Macquarie Point Multipurpose Stadium

Public Hearing Technical Note

Technical Note Number	9
Subject	Precinct car park
Date	8 July 2025

Attachment 1
Revised Precinct Car Park Plans

Drawing Title
**GENERAL ARRANGEMENT NORTHERN
CAR PARK**

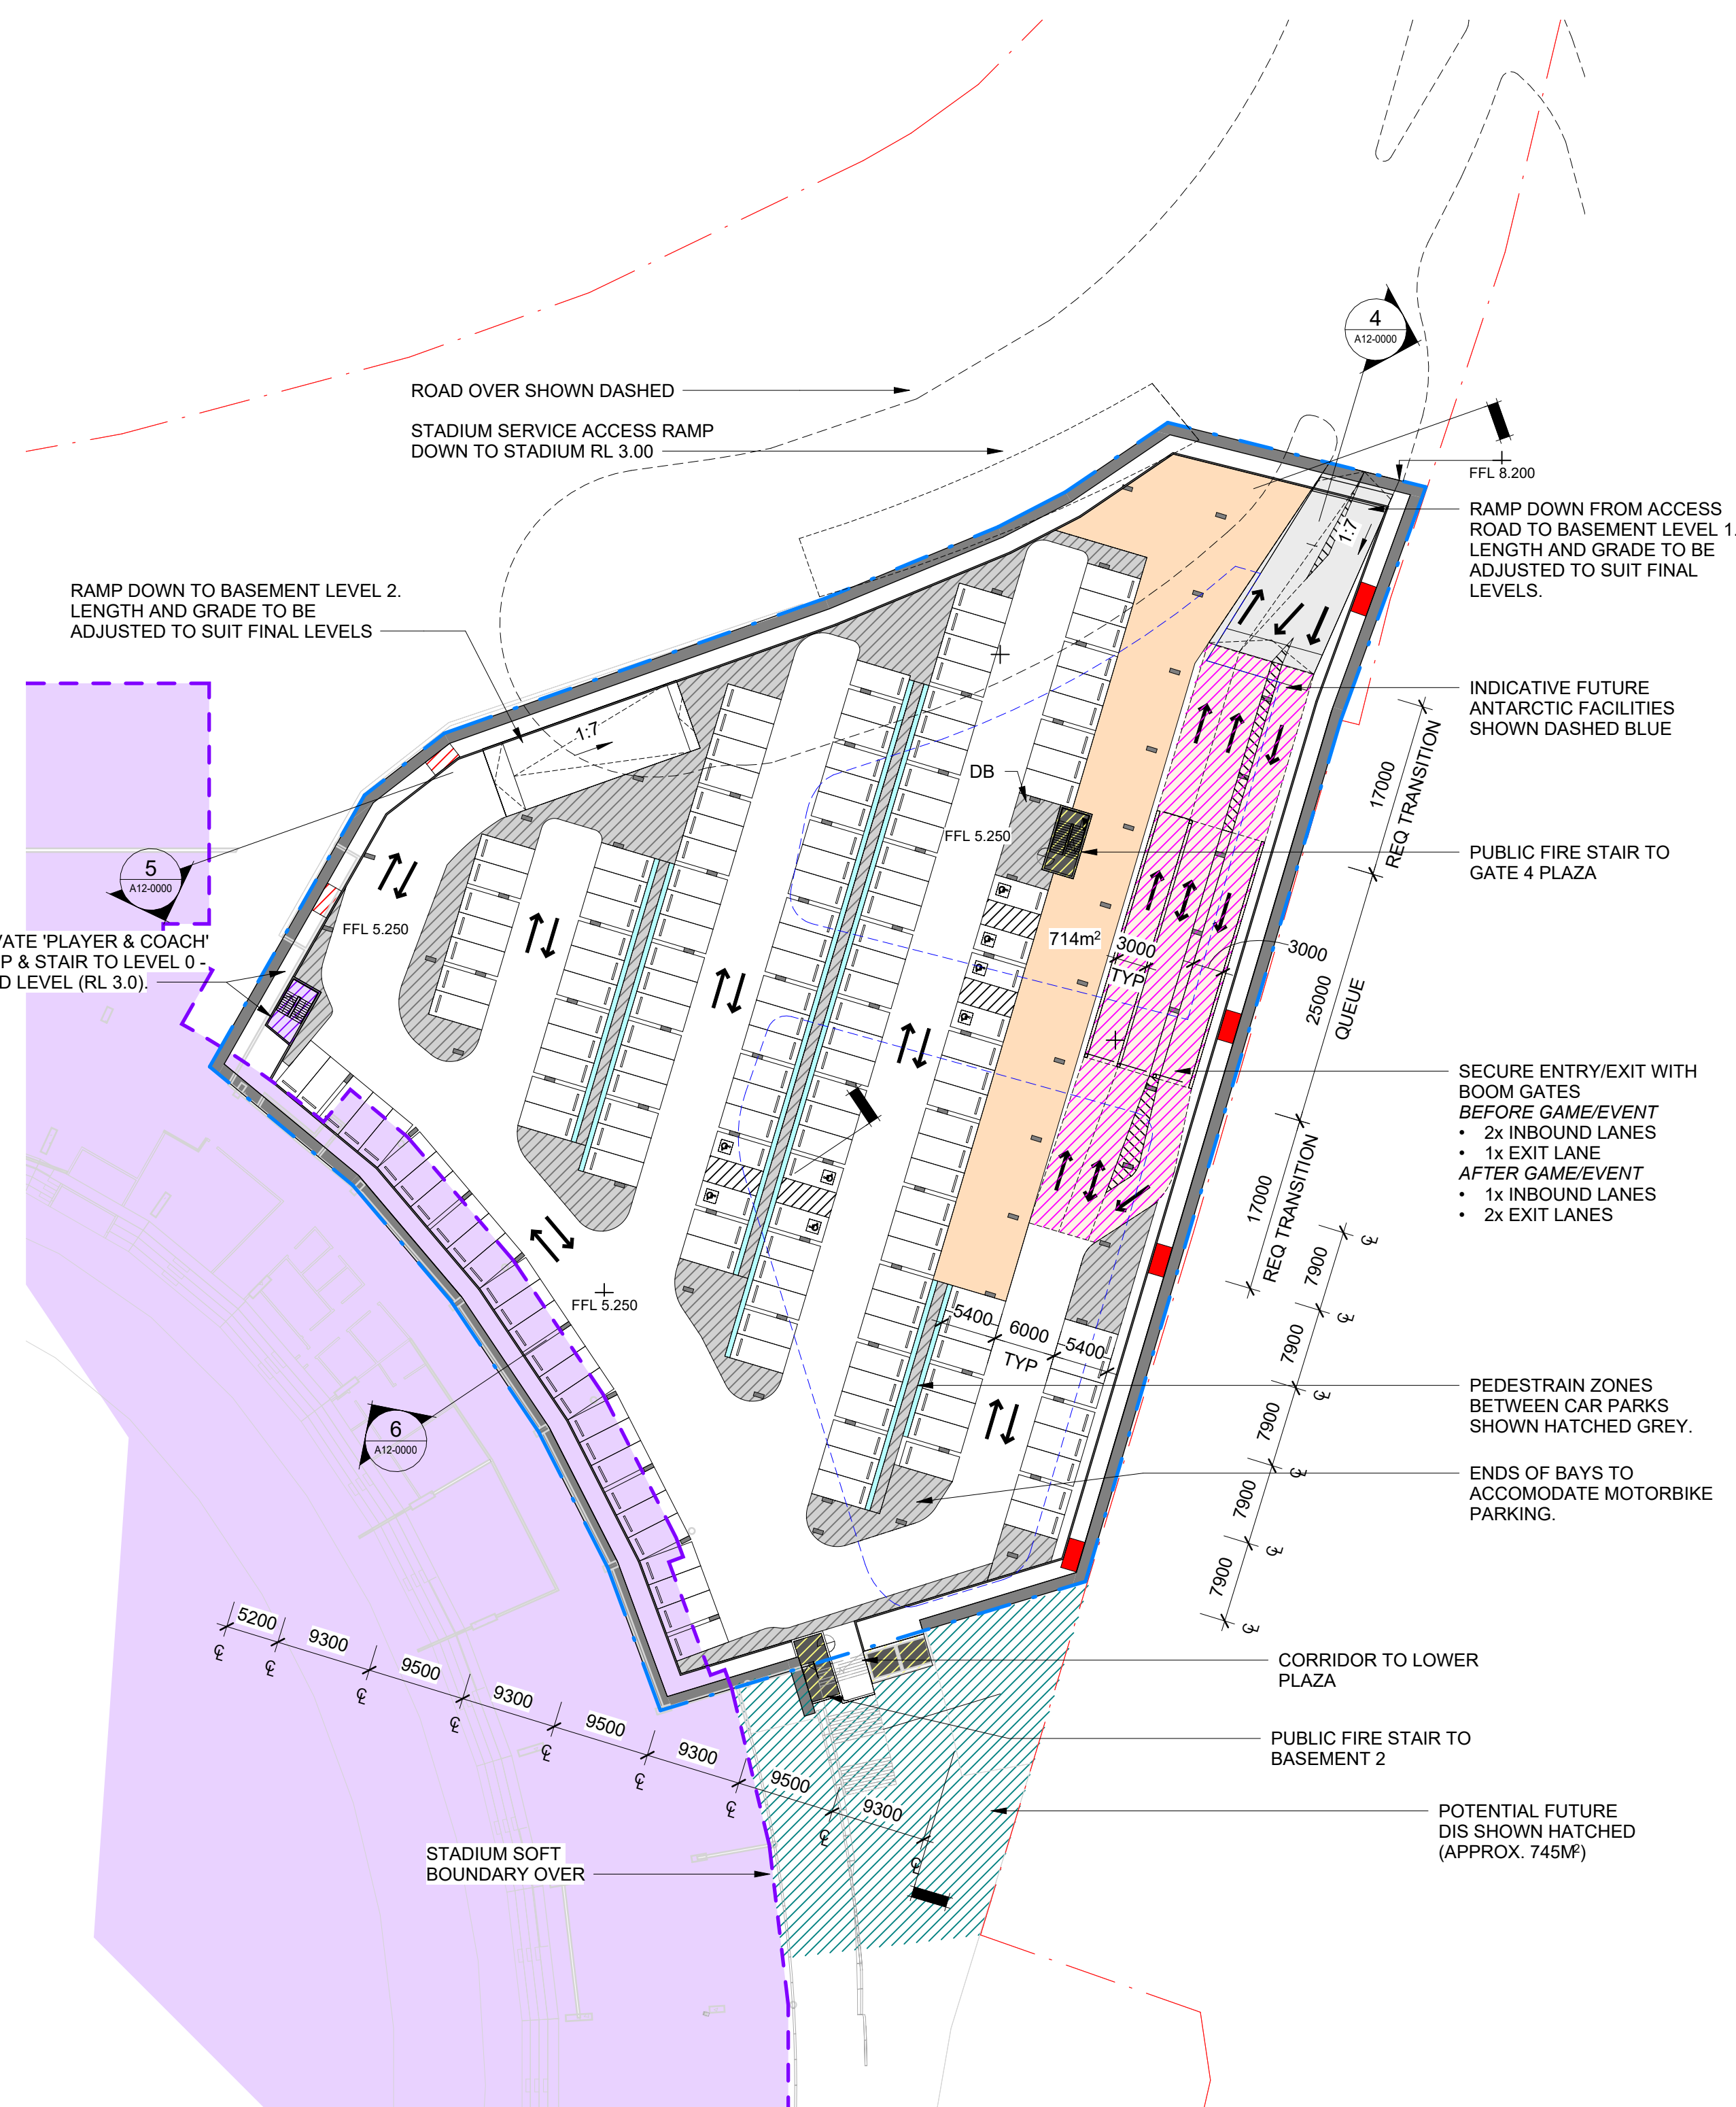
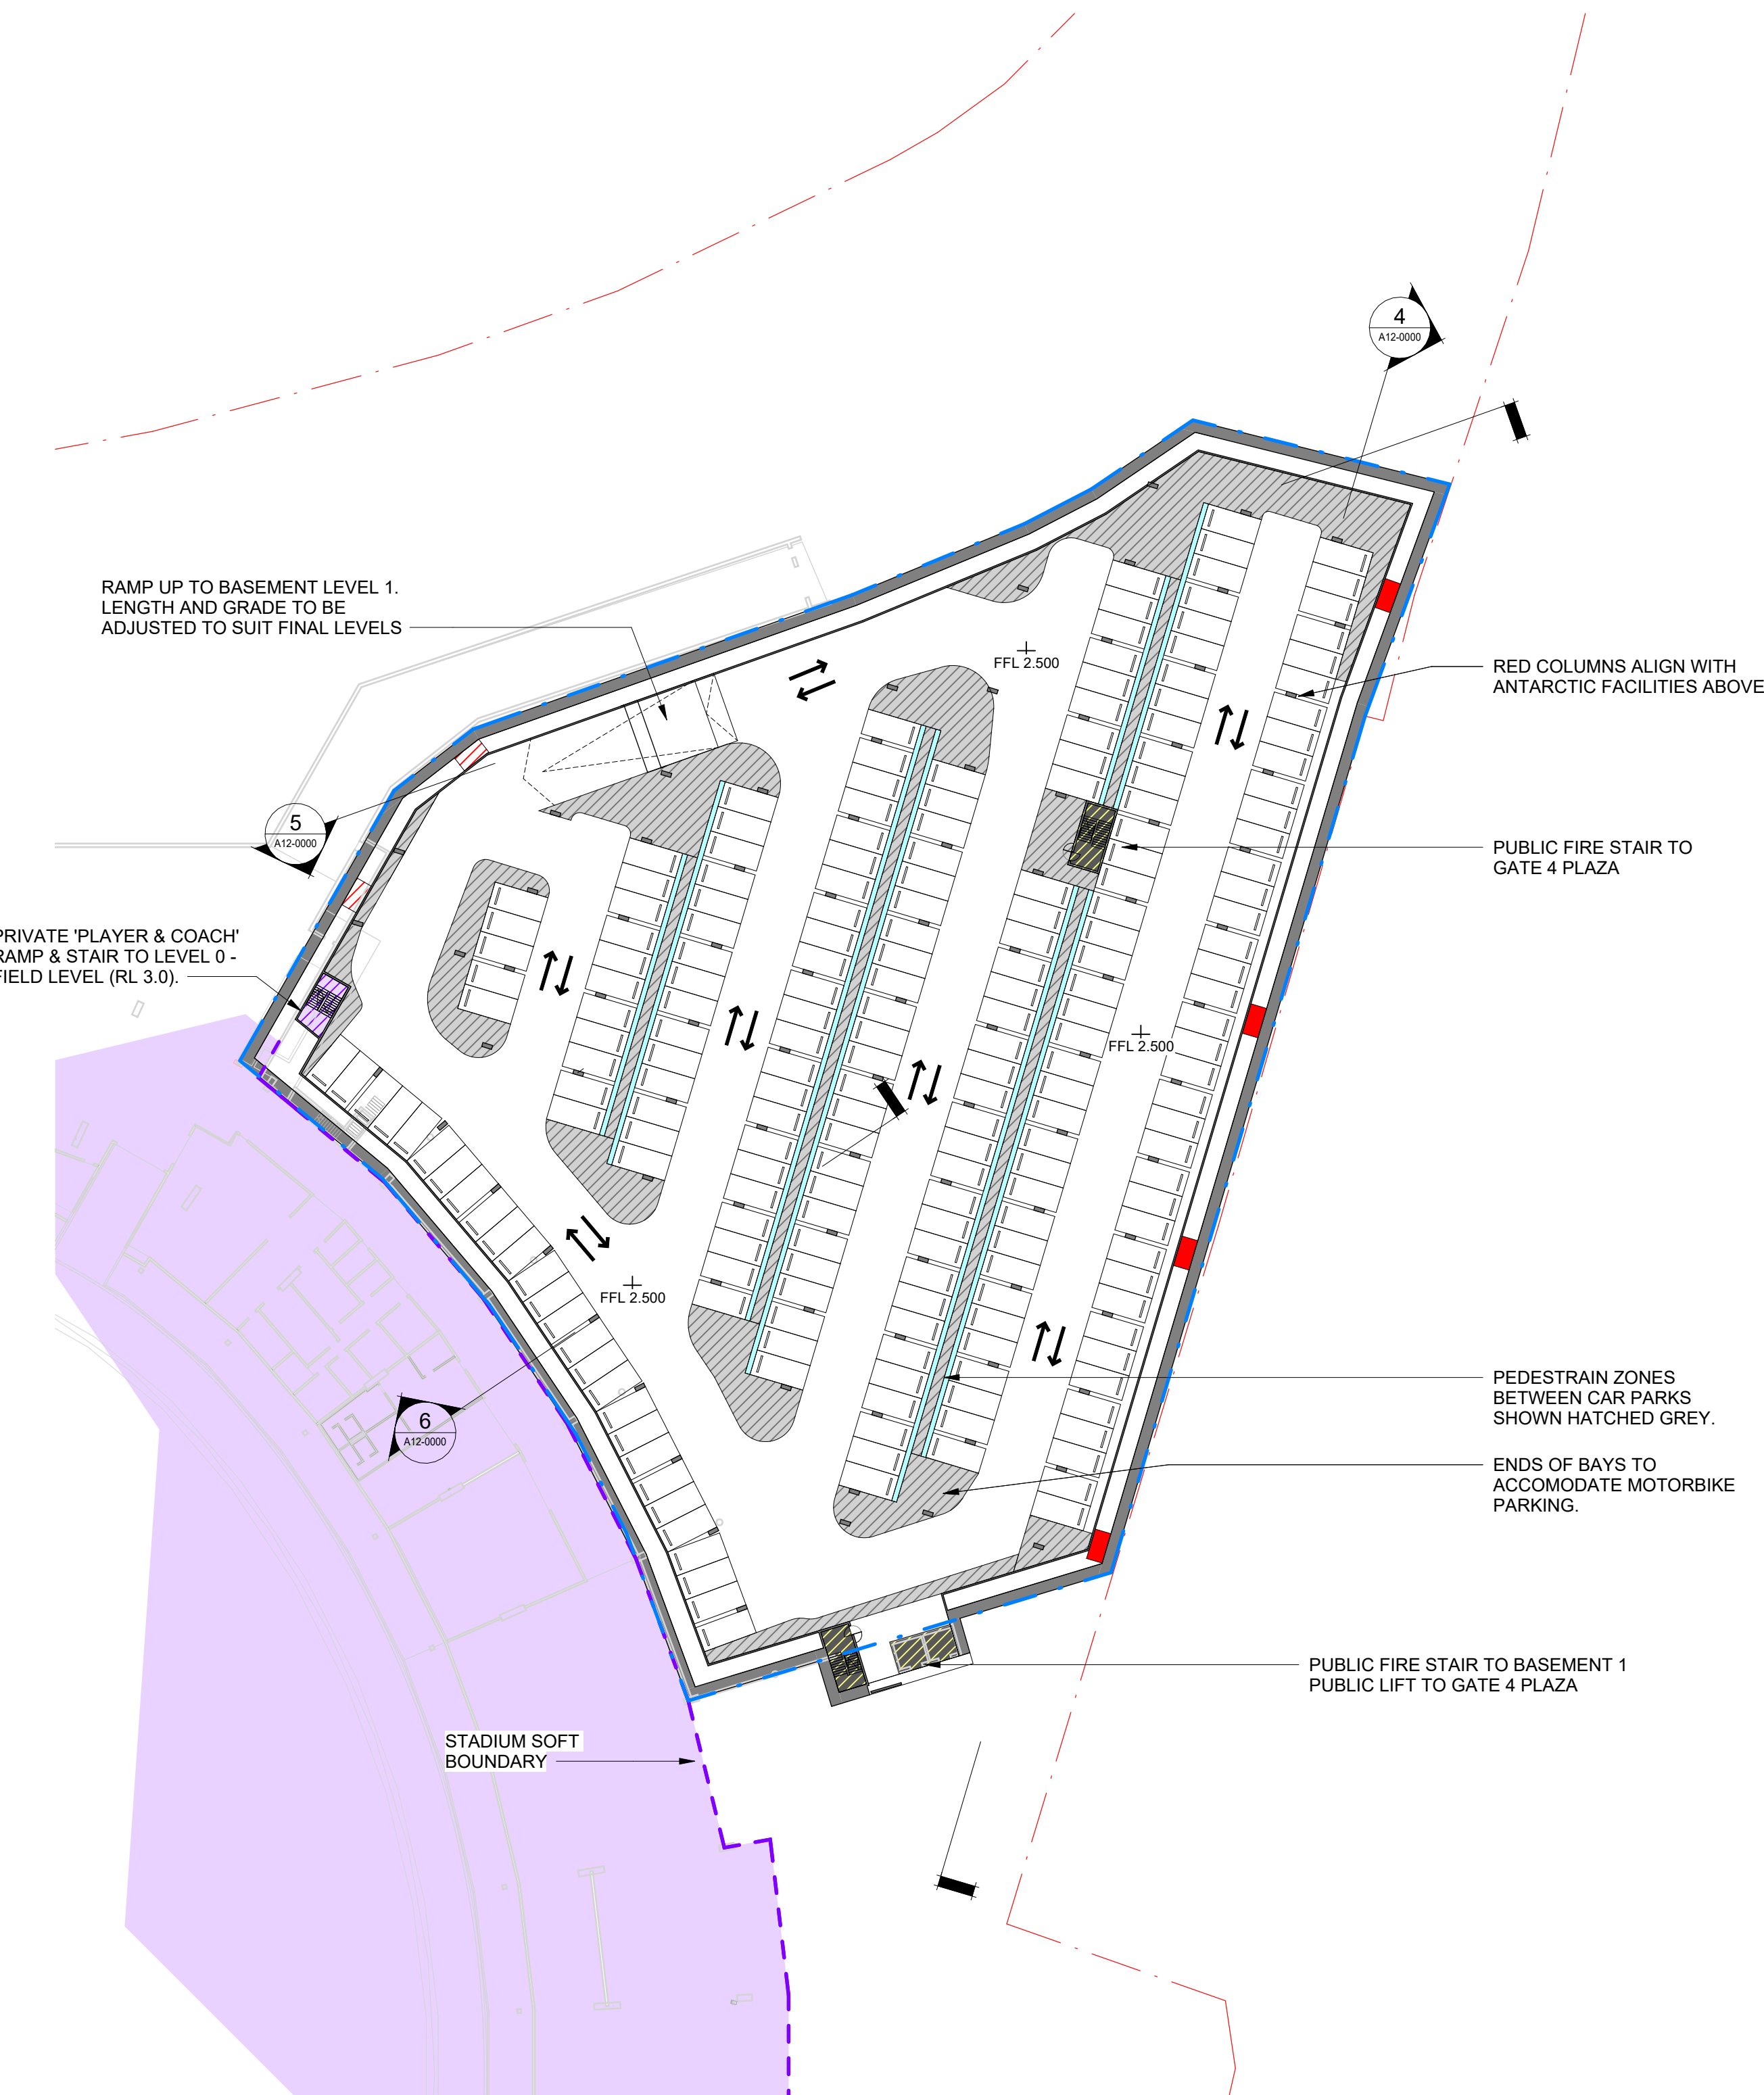
- 2.3 Through the detailed design process and in response to the Draft IAR and representations, the car park has been reduced to two levels below ground. The deletion of one level of car parking keeps the finished floor level to 2.5 relative level which means that the car park remains above the groundwater table. The groundwater table ranges between 1.1 – 1.5 metres AHD in the area where the car park would be located, on average this means the carpark will be approximately 1 metre above the groundwater table. The modified design reduces the scope of environmental matters for regulation and management.

- 2.4 A revised plan is provided at **Attachment 1**, which was also submitted as part of the Technical Note 5 which provides a summary of updates to the submitted plans. The number of car parks shown on the revised plan is 374.
